ENGINES 271.940 in MODEL 203.042 /242 /742, 209.342 /442
ENGINES 271.941 in MODEL 211.042 /242
ENGINES 271.946 in MODEL 203.046 /246 /746
ENGINES 271.948 in MODEL 203.040 /240 /740
ENGINES 271.921 in MODEL 203.730
ENGINES 271.942 in MODEL 203.043 /243 /743, 209.343
ENGINES 271.955 in MODEL 209.341 /441
ENGINES 271.956 in MODEL 211.041 /241
ENGINES 271.957 in MODEL 203.741

Modification notes

P05.20-2126-05

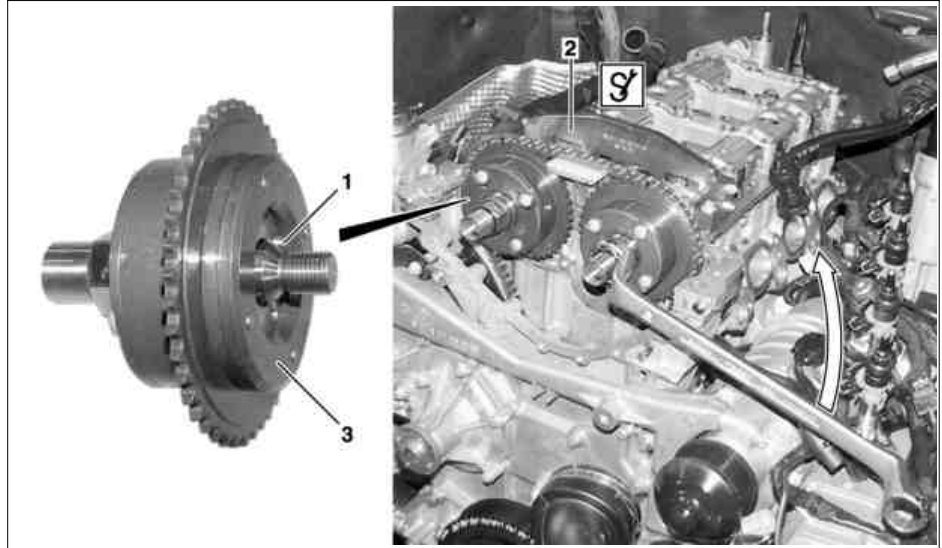
16.4.03	Change in the repair method, to release the timing chain, the chain tensioner is no longer removed, instead the slide rail in the cylinder head is pushed back	Step 5	
---------	--	--------	--
